# CENTRAL FLORIDA EXPRESSWAY AUTHORITY

**AGENDA**  
**SPECIAL BOARD MEETING**  
**July 20, 2021**  
**8:30 a.m.**

# SR 417 and SR 528 Intercity Rail Alignments

Evaluation of Project Cost Estimates

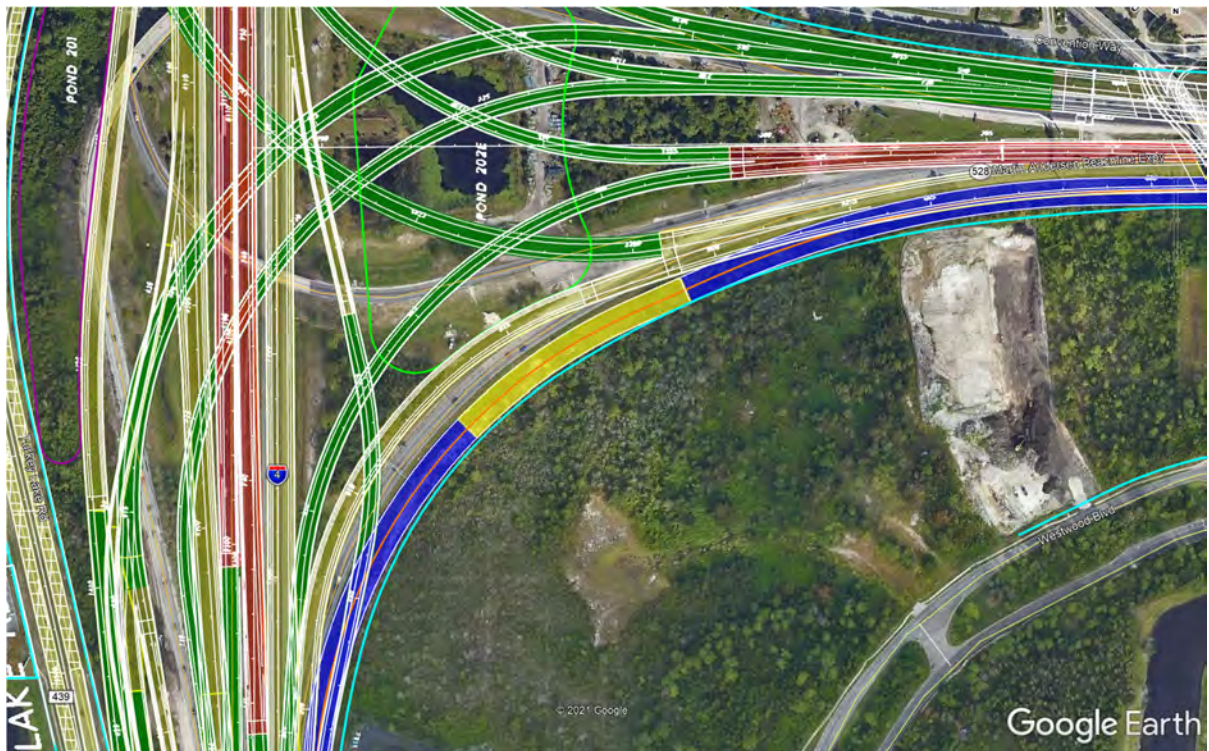
- Q. Upon review of the I-4 BTU plans and comparing that to your KMZ, do you have an exhibit to show how you can fit the proposed rail alignment will fit within the R/W at the southwest quadrant of the SR 528/I-4 interchange with the I-4 BTU improvements?

- A. The kmz files of the I-4 BtU design in this section along with the kmz file of the TVR / SR 528 alignment were provided to Keith Jackson (Dewberry). Below is a screenshot of this section.

Exhibit A

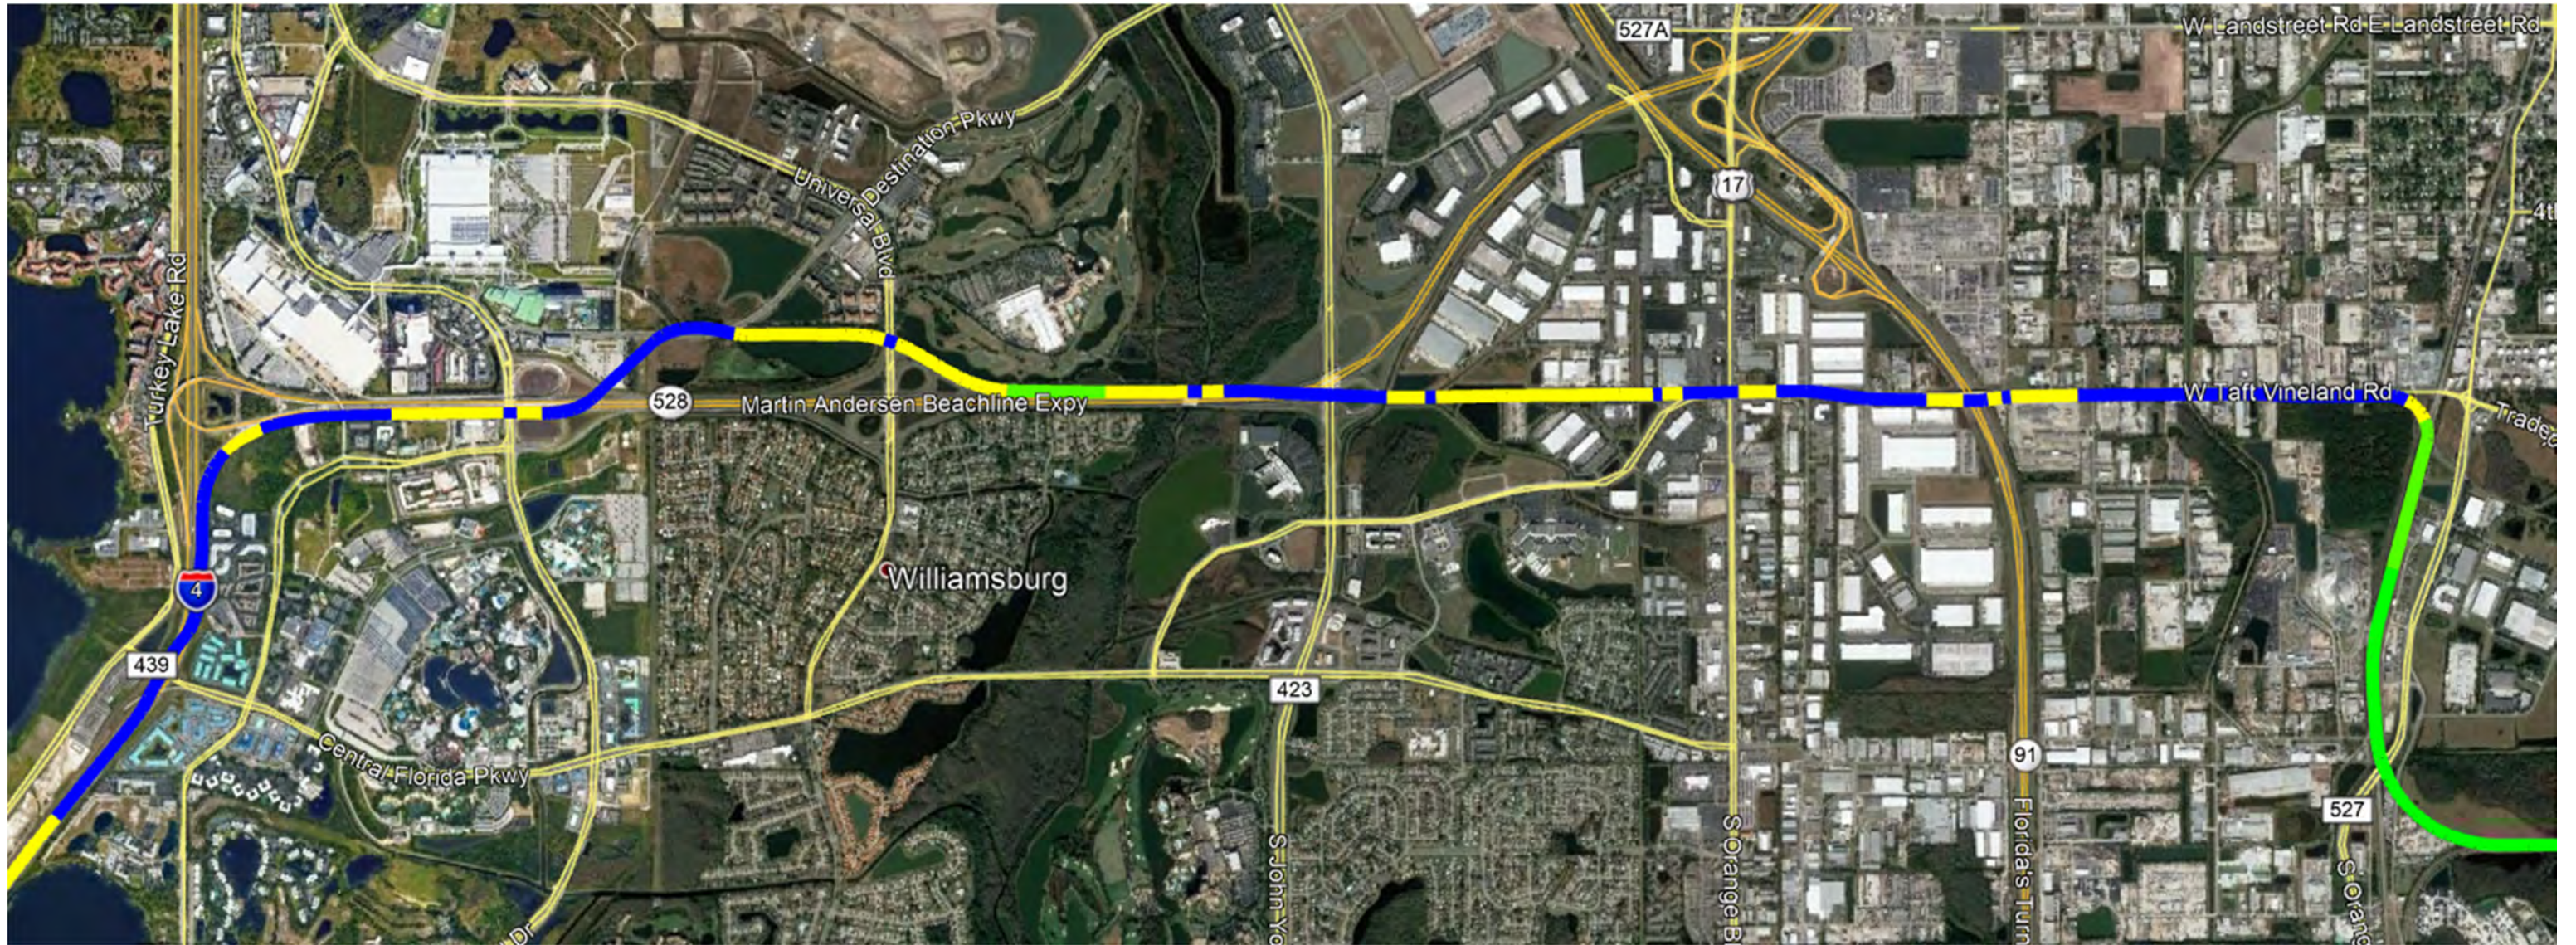
- Q. Upon further review, the FLHSR plans show the tracks on MSE walls approaching and departing the bridge overpass at SR 535. The kmz (VHB alignment) shows these same limits at grade. Please confirm the intent and your estimate was based on the MSE walls approaching this bridge.

- A. Revisions have been made to the quantities to reflect this change.
- Q. Also, the KMZ rail alignment at grade under the Darryl Carter Parkway overpass will be in conflict with the bridges center piers located in the center of the existing median. What is the plan to deal with this conflict? Replace the bridge? Offset the rail corridor?

- A. The typical section and plans for the currently approved I-4 BtU design includes the rail corridor at grade under the existing Darryl Carter Parkway overpass. Please see the attached exhibit I-4 BtU typical section.

### Exhibit C – Increased 417 Route Length

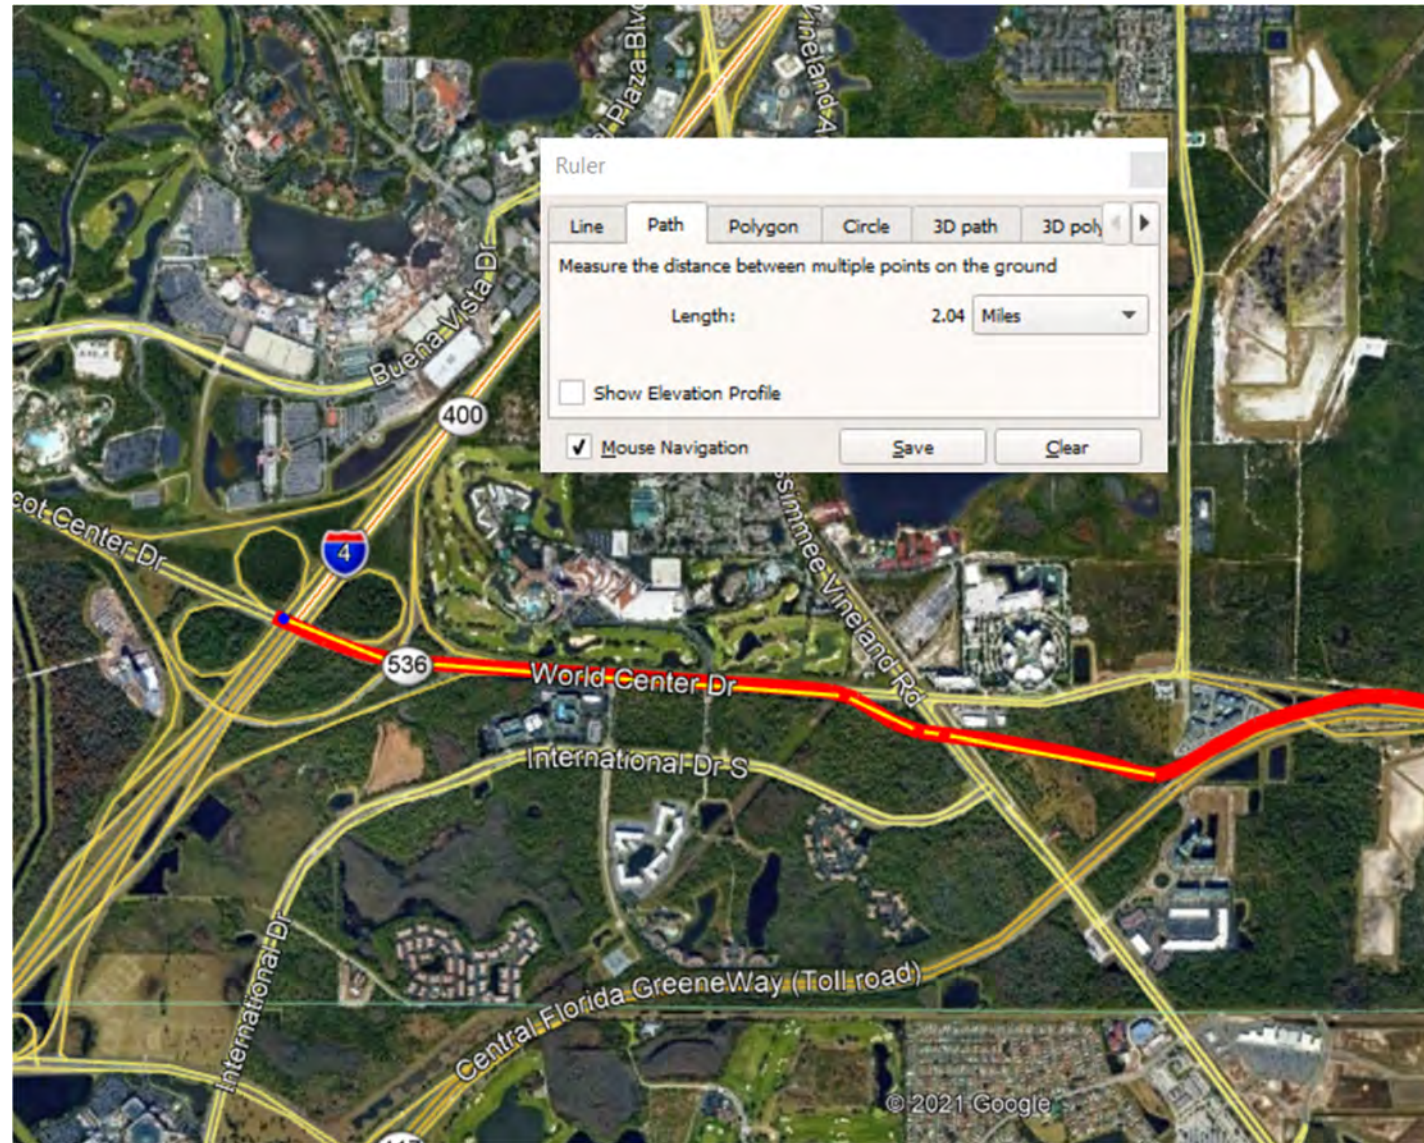
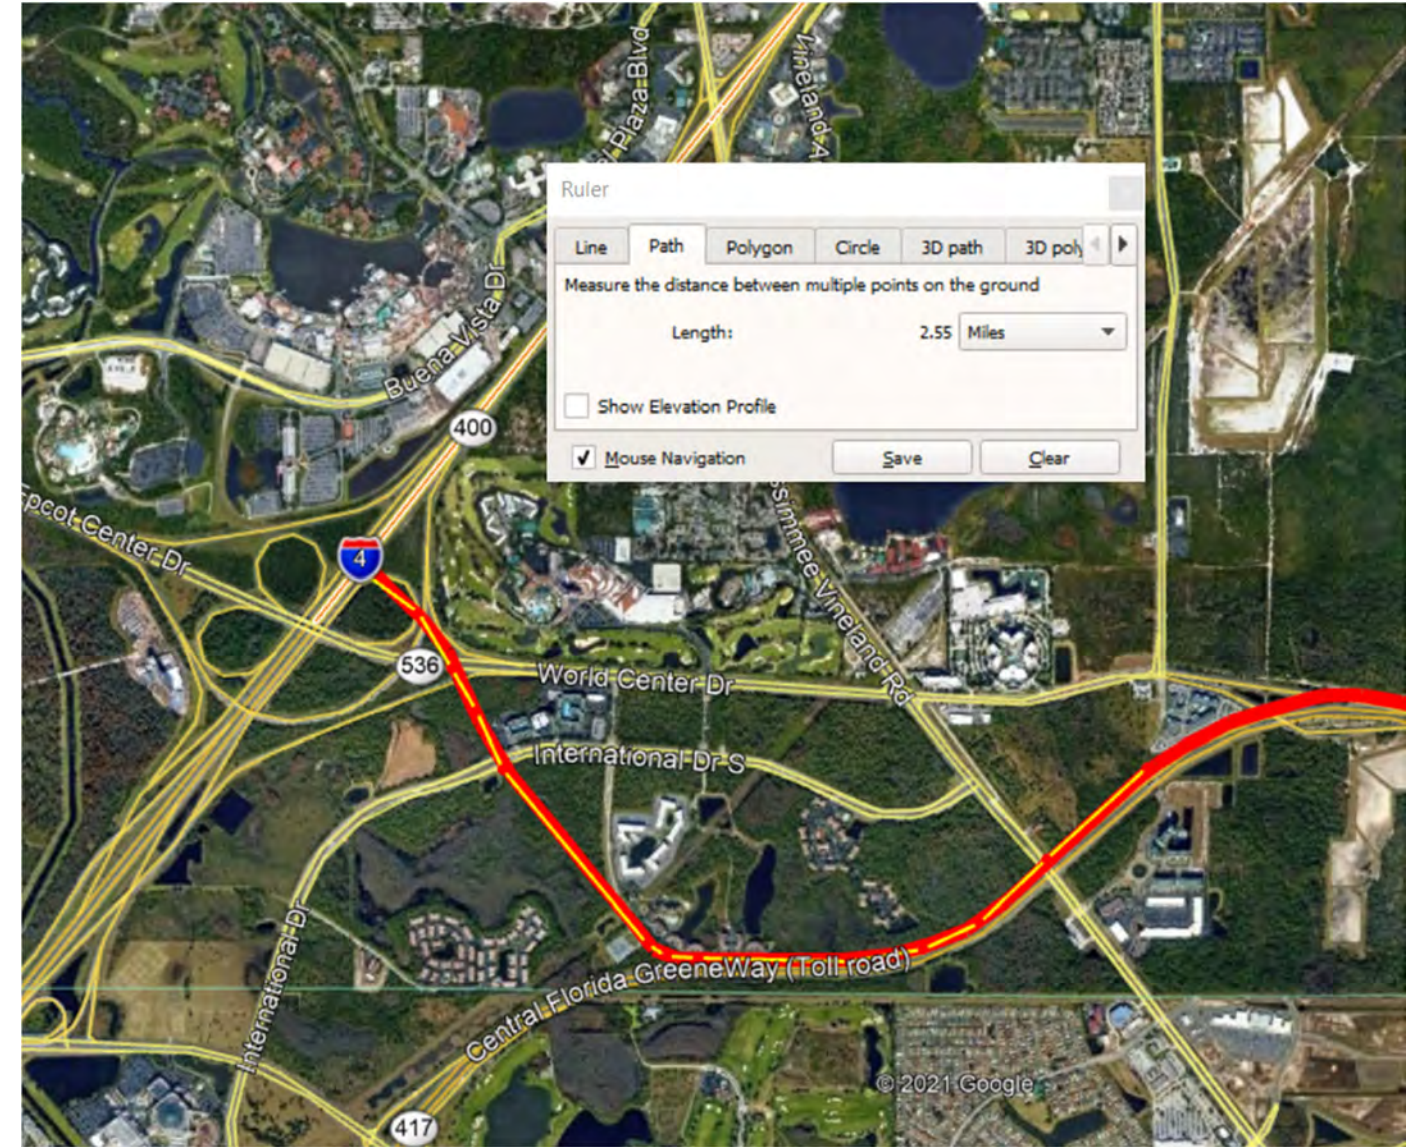
The new alignment from 417 to Disney appears to add .5 miles to the overall 417 route distance. Using Brightline’s per mile route cost for this section adds a minimum of \$40 million.

Exhibit D – MSE Wall Along SR 417 Route

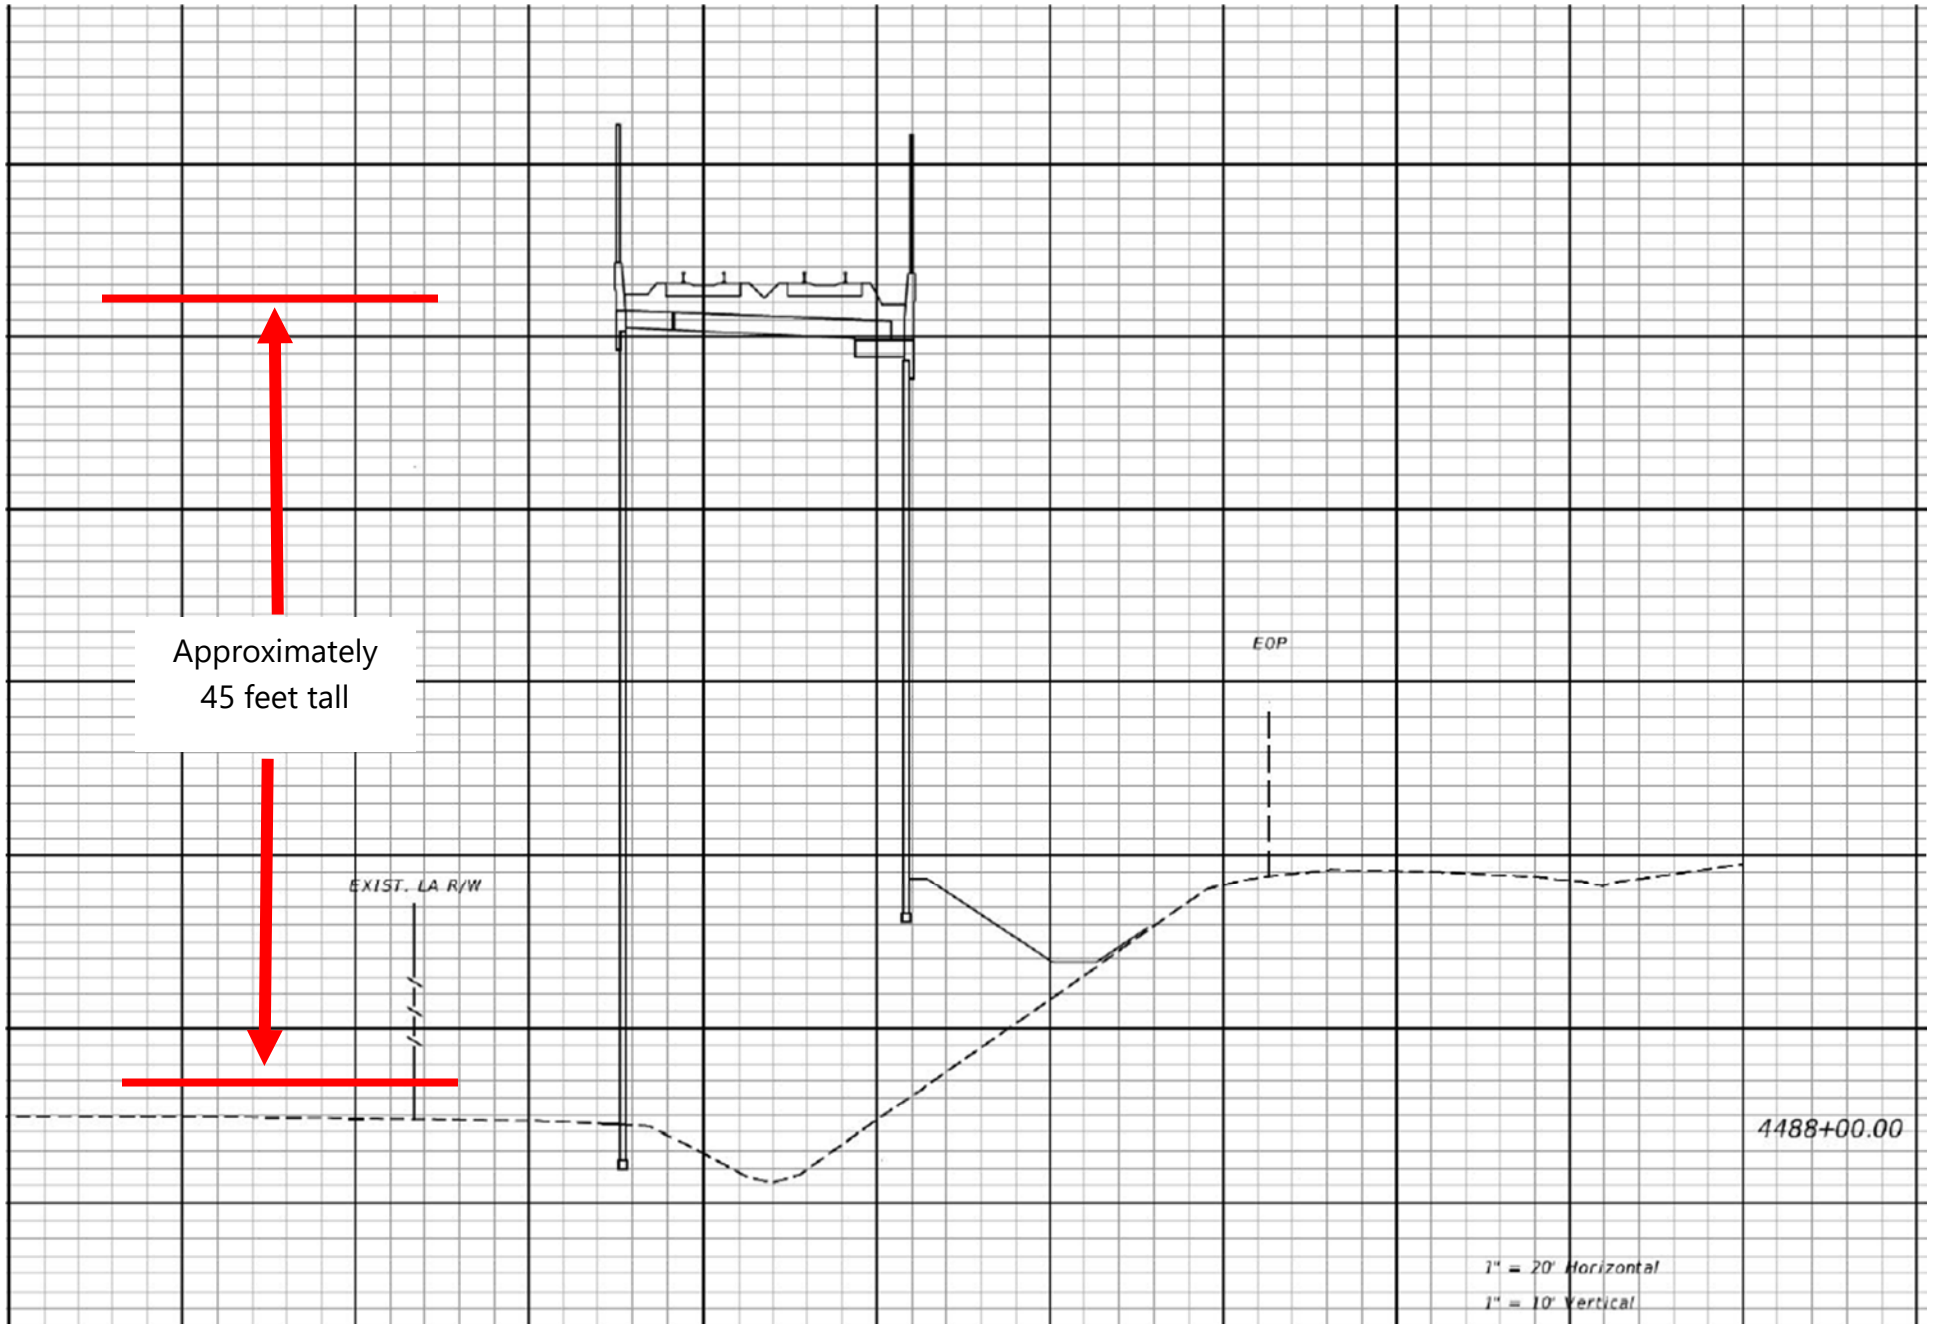
The unit costs of the walls for the 417 route and the Convention Center route cannot be the same. The costs of the walls on the 417 will be greater due to the increased heights of walls shown in the plan, restrictive access along the property line, and constructability issues associated with construction along 417, etc. Over the length of the alignment, the delta in unit cost combined with the significant amount of wall could create a significant increase in the 417 route estimate. Actual unit costs associated with these specific walls are required in order to make a reasonable comparison.
